# Access Compliance Report

## Public Rights-of-Way

### (Curb Ramps)

Intersection ID: 53629	Main Street: PROVIDENCE_RD_WEST	Cross Street: CAMBRIDGE_FOREST_CT	Location: SE
ADA ID: 96B05F720BD8	Ramp Type: PerpDiag	Initial Pass/Fail: Fail	Overall Compliance: No
Codes/Mitigation Info/Possible Solution		Field Measurements/Component Compliance	
Severity Score: 21.25

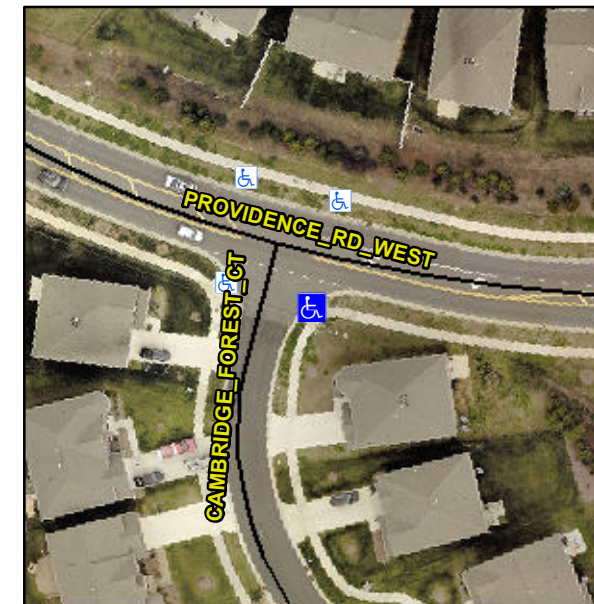
**Not Found, R304.5.1, R304.5.3**

Compliance	Description	Data	Compliance	Description	Data
N/A	Ramp Length (in)	48.0	Yes	Ramp Slope (%)	5.6
No	Ramp Width (in)	46.5	No	Ramp XSlope (%)	6.9
N/A	Flare Type LT	N/A	N/A	Flare Type RT	N/A
N/A	Flare Slope LT (%)	N/A	N/A	Flare Slope RT (%)	N/A
N/A	Flare Traversable LT?	N/A	N/A	Flare Traversable RT?	N/A
N/A	Landing Length (in)	N/A	N/A	DWS Provided?	N/A
N/A	Landing Width (in)	N/A	N/A	DWS Contrast?	N/A
N/A	Landing Slope (%)	N/A	N/A	DWS Length (in)	N/A
N/A	Landing X Slope (%)	N/A	N/A	DWS Full Width?	N/A
N/A	Landing Curb? (Y/N)	N/A	N/A	DWS Offset (in)	N/A
N/A	Shared Landing?	N/A			
N/A	Gutter Ponding?	N/A	N/A	Gutter Slope (%)	N/A
N/A	Gutter Lip Ht (in)	N/A	N/A	Gutter X Slope (%)	N/A
N/A	Painted X Walk1?	No	N/A	Painted X Walk2?	No
	X Walk 1 Direction	To NE		X Walk 2 Direction	To NW
N/A	X Walk 1 Width (in)	N/A	N/A	X Walk 2 Width (in)	N/A
	X Walk 1 Slope (%)	2.2		X Walk 2 Slope (%)	3.5
	X Walk 1 X Slope (%)	3.1		X Walk 2 X Slope (%)	4.3

**Remove & Replace Curb Ramp With Two New Directional Ramps or Equivalent.**
